Addendum # 2

Property: Moisture Mitigation Plan at David Pinney Brick Barn
Address: 58 West Street
Location: Windsor Locks, CT
Date: April 6, 2026

This Addendum #2 is issued to modify the contract documents as follows:

**MOISTURE MITIGATION AT
DAVID PINNEY BRICK BARN**
58 West Street, Windsor Locks, CT 06096
Town of Windsor Locks
6 Stanton Road, Windsor Locks, CT 06096

A-3.0

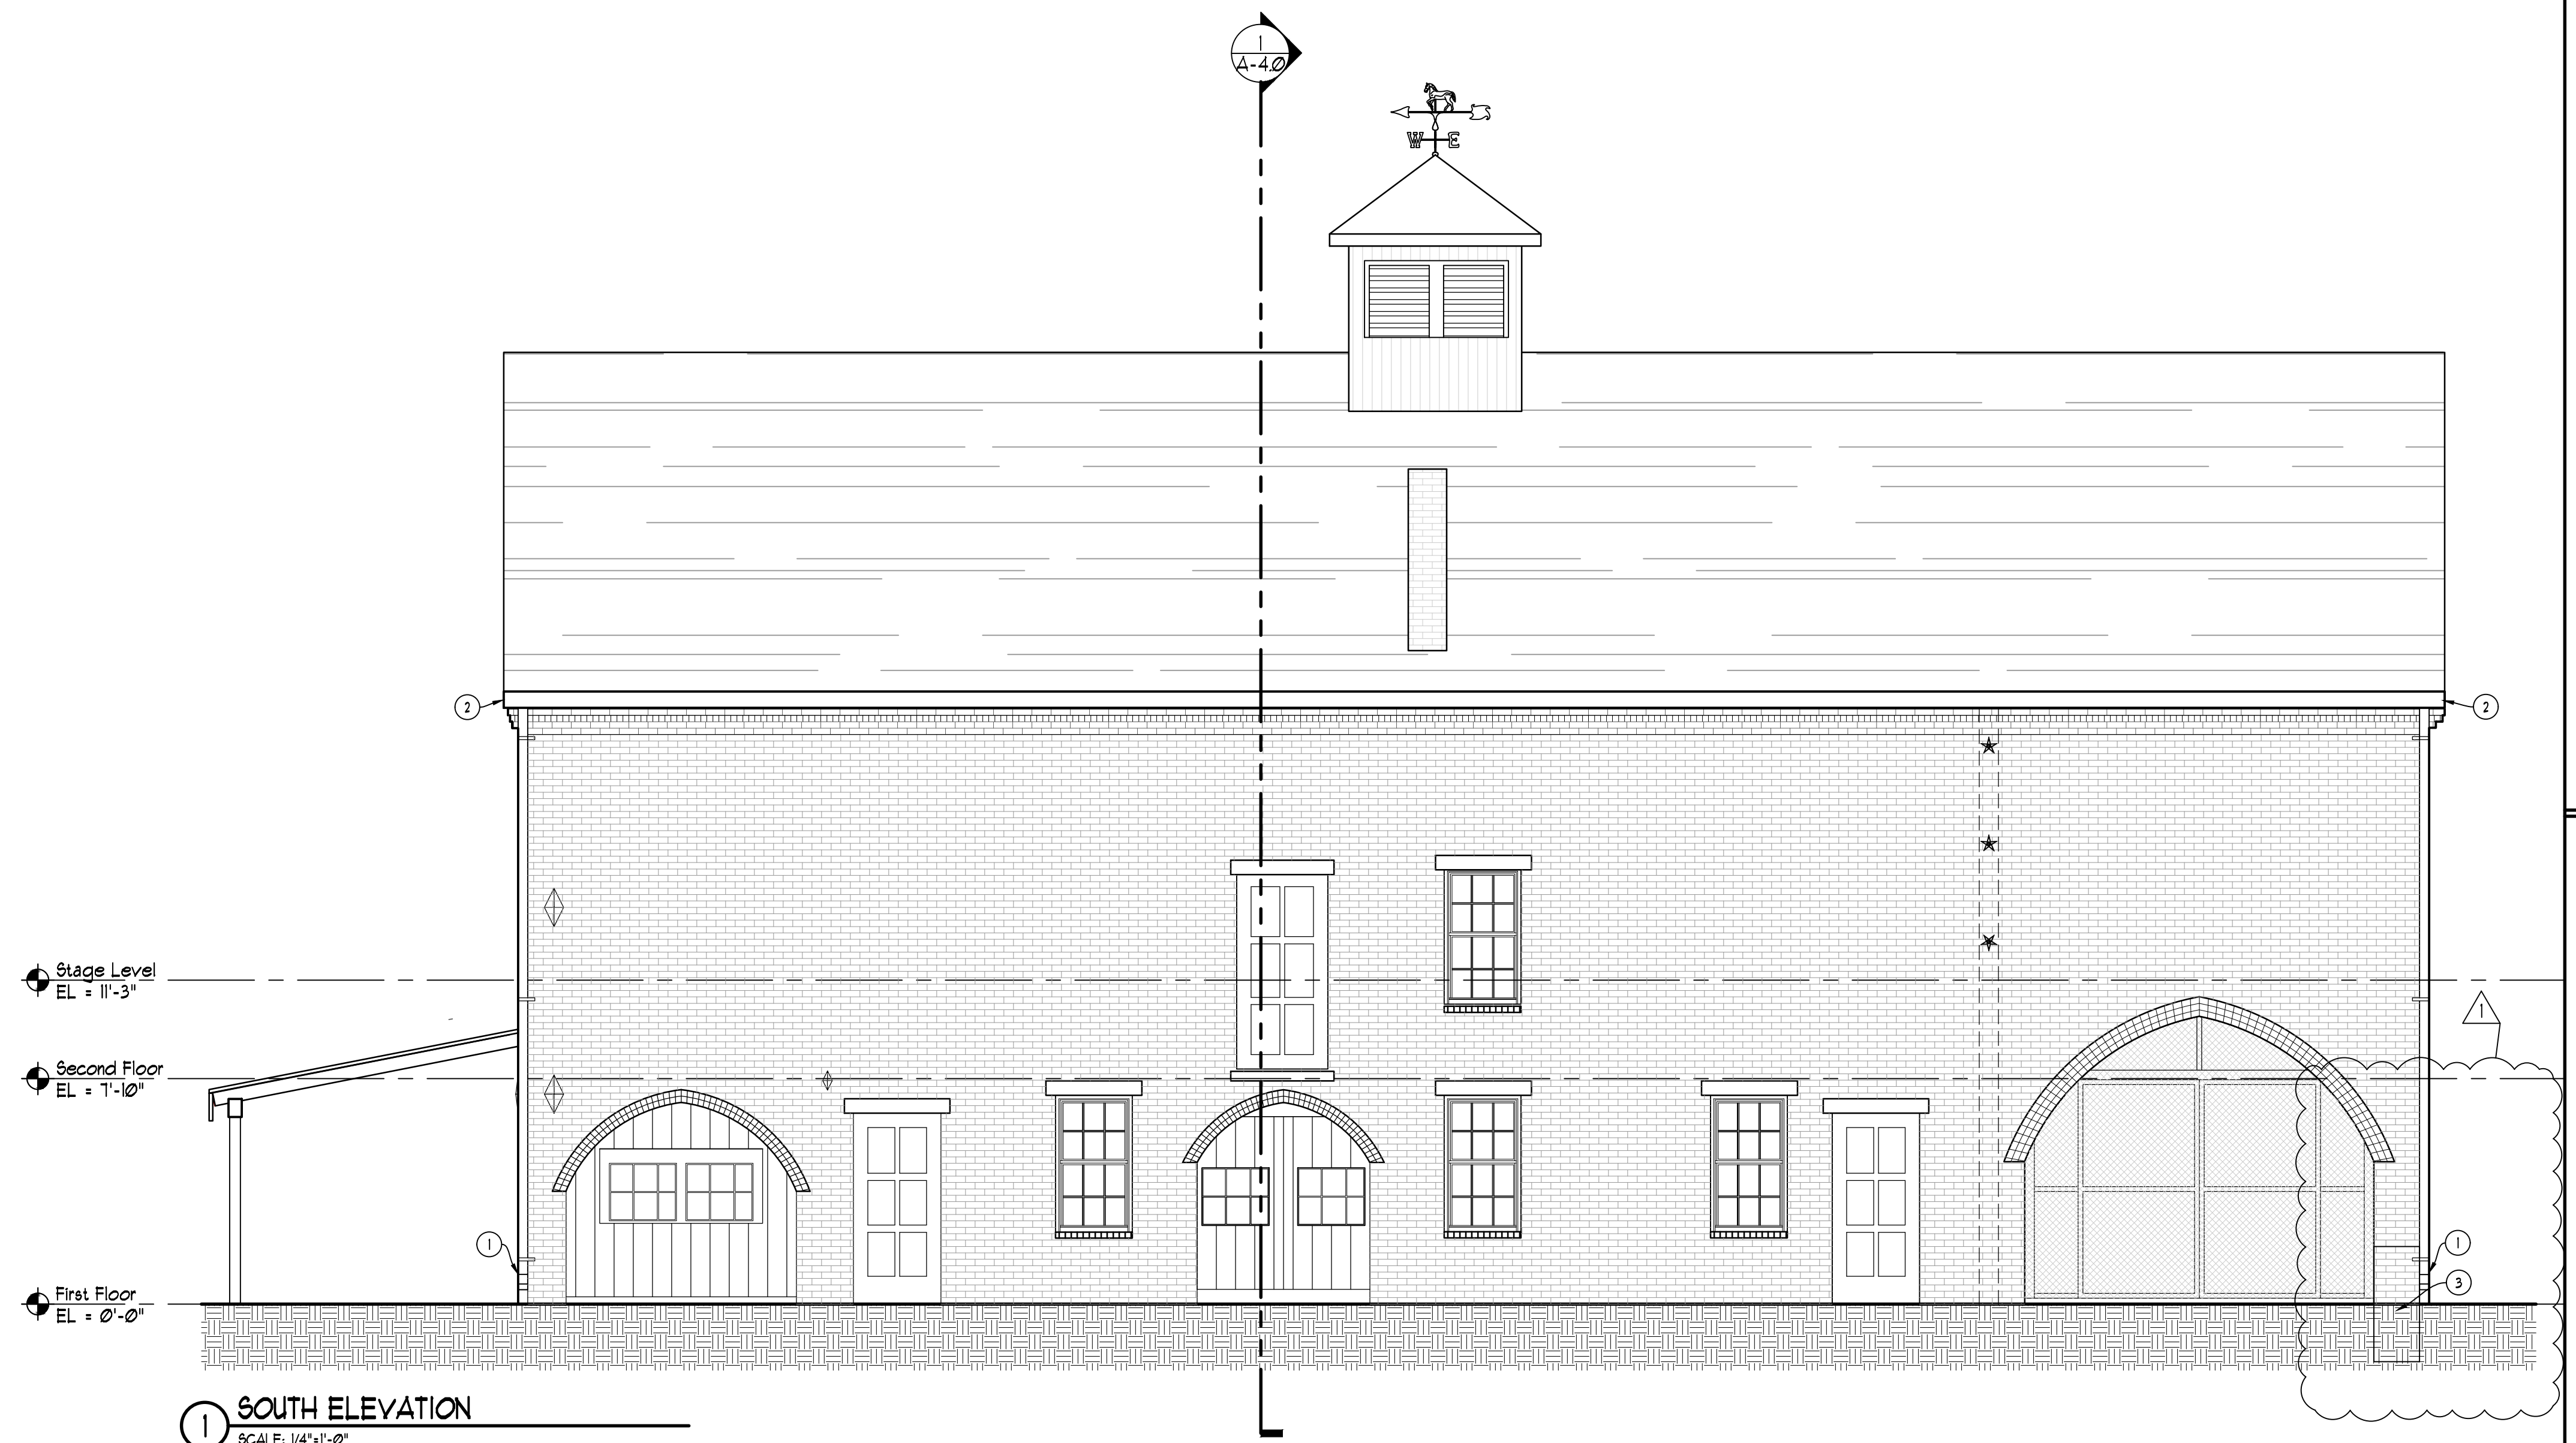
Limited exterior masonry repair has been added to the southeast corner of the building. Refer to exterior elevations.

- ① New 3"x4" Down Spout Connected To underground storm. Refer To 3/A-41 For Detail And To Civic Drawings.
- ③ Repair Masonry. Remove and replace/rebuild front wythe of brick on south facade 1'-1" wide from building corner to masonry opening, 8 courses above grade and 8 courses below grade. On east elevation, repoint 12 SF of masonry joints.

A-3.3

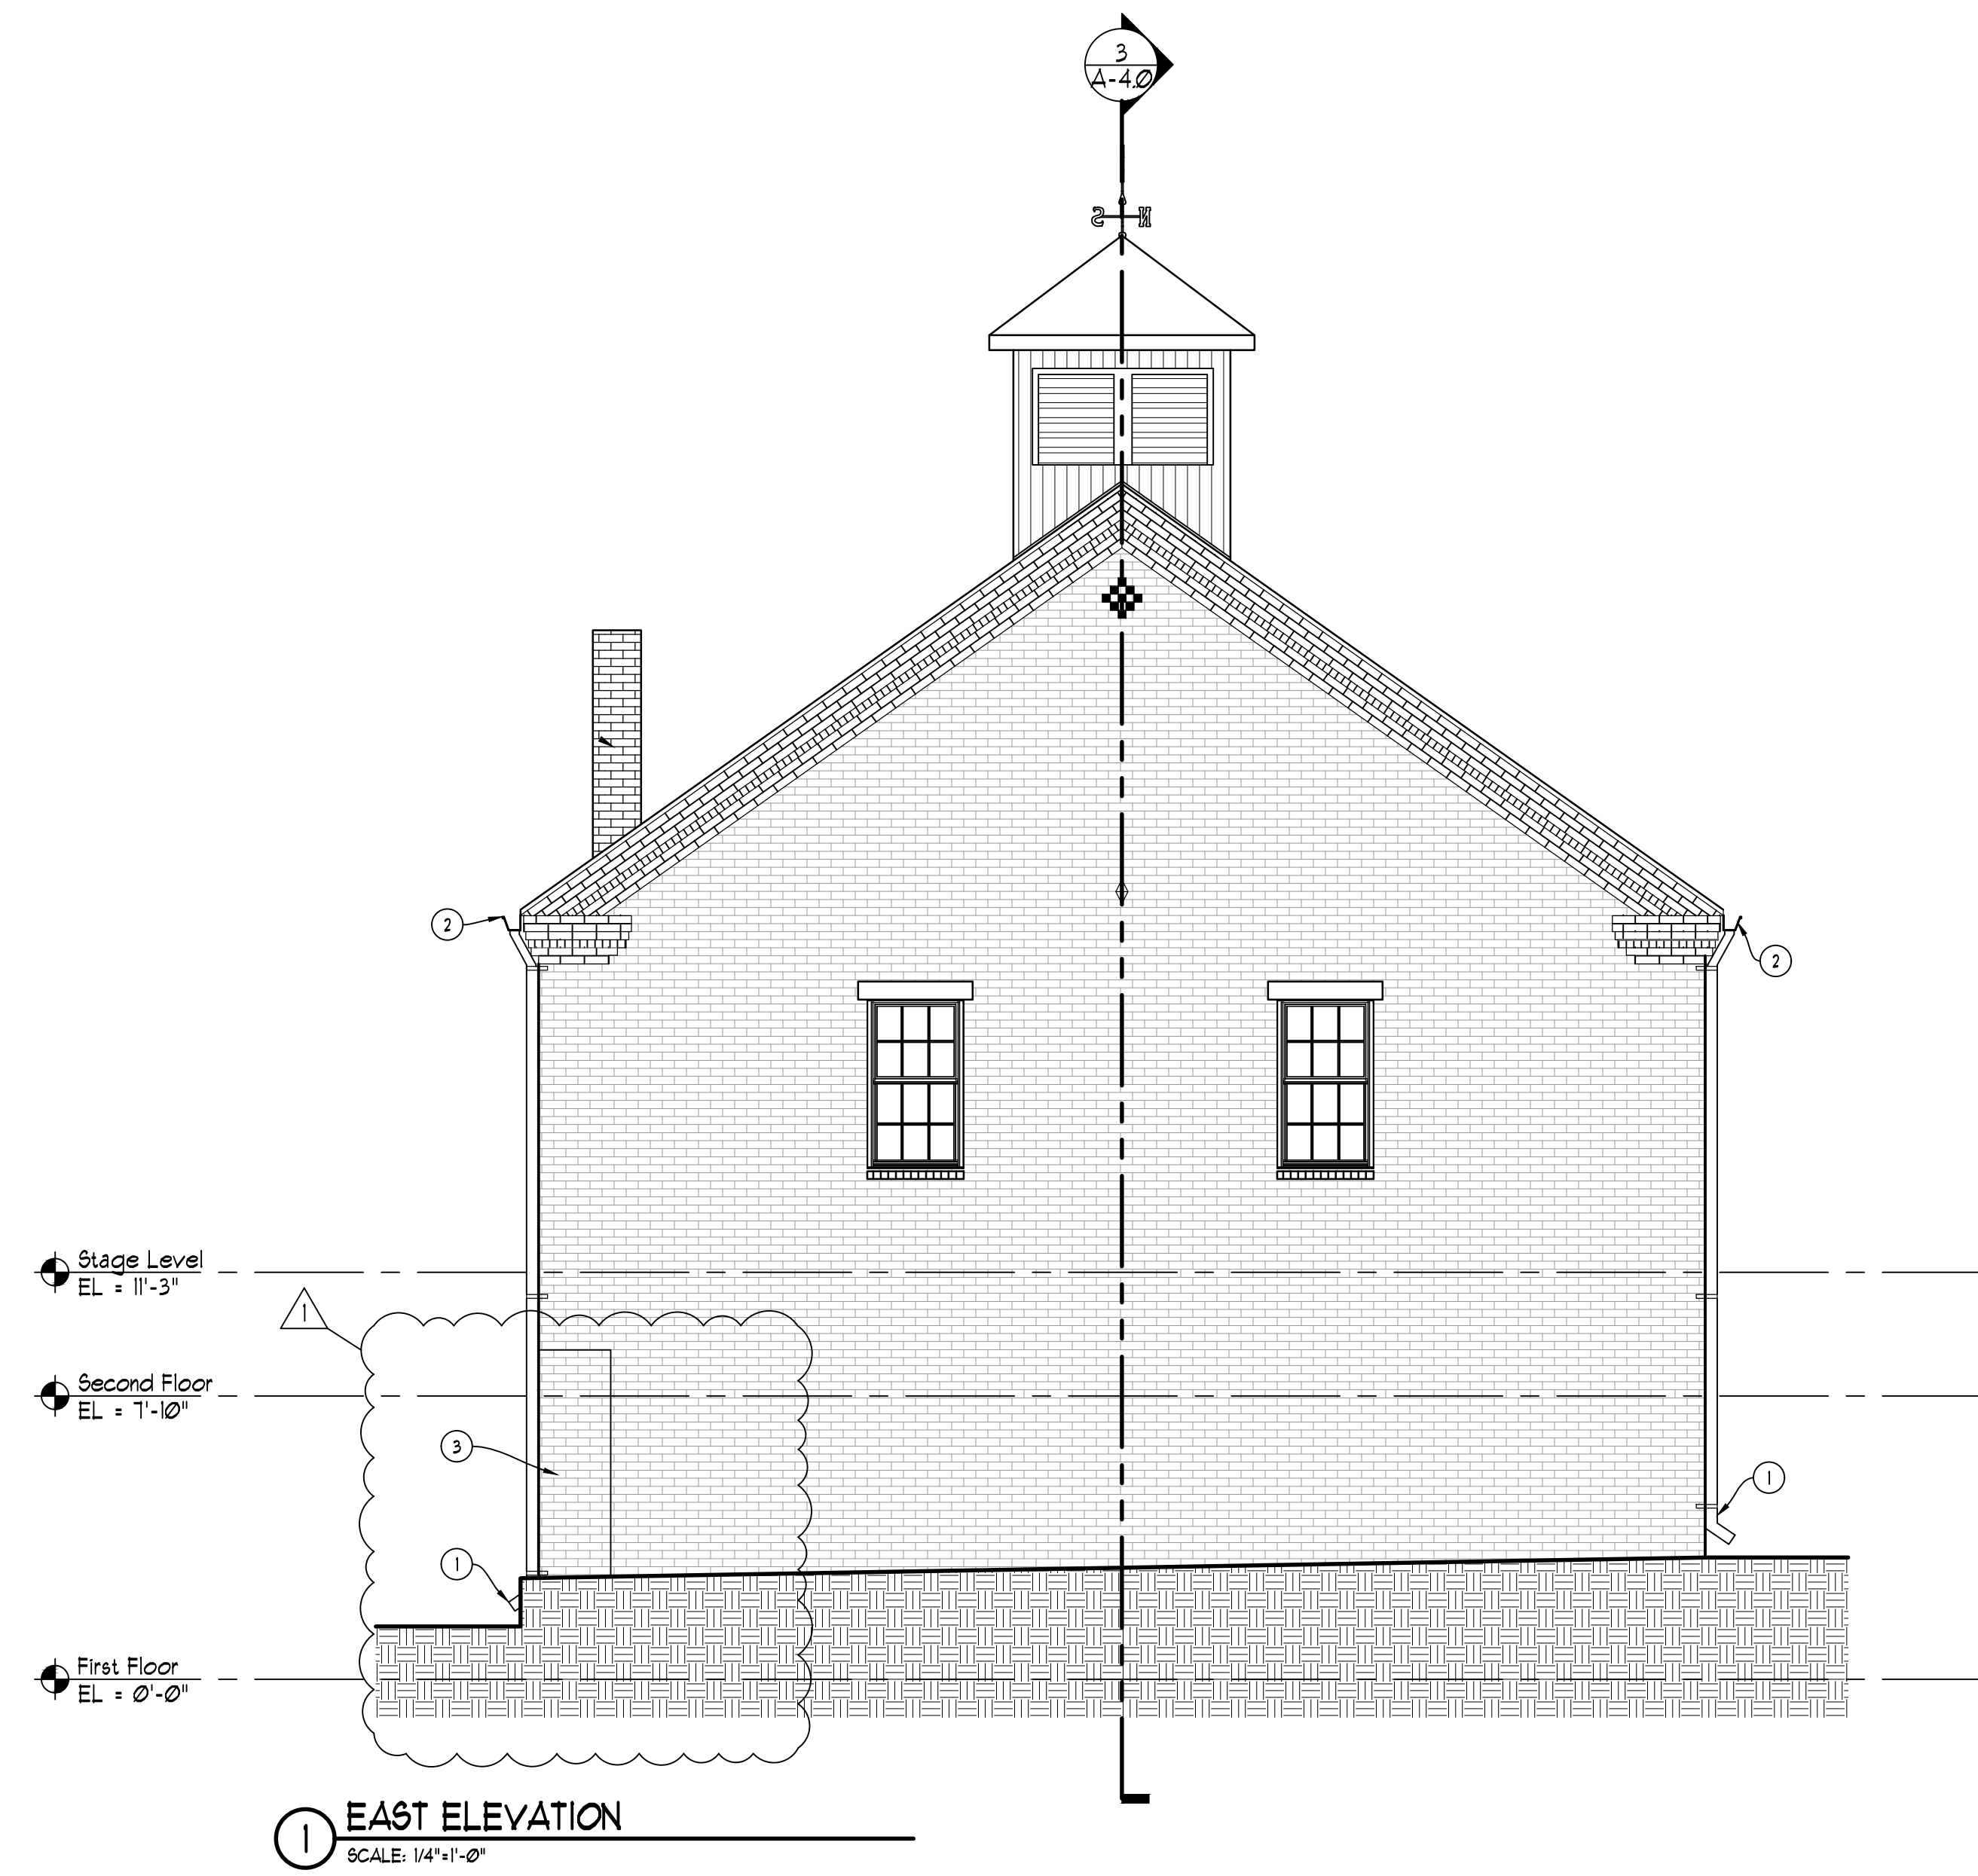
- ① New 3"x4" Down Spout Connected To underground storm. Refer To 3/A-4.1 For Detail And To Civic Drawings.
- ② Repair Masonry. Remove and replace/rebuild front wythe of brick on south facade 1'-1" wide from building corner to masonry opening, 8 courses above grade and 8 courses below grade. On east elevation, repoint 12 SF of masonry joints.
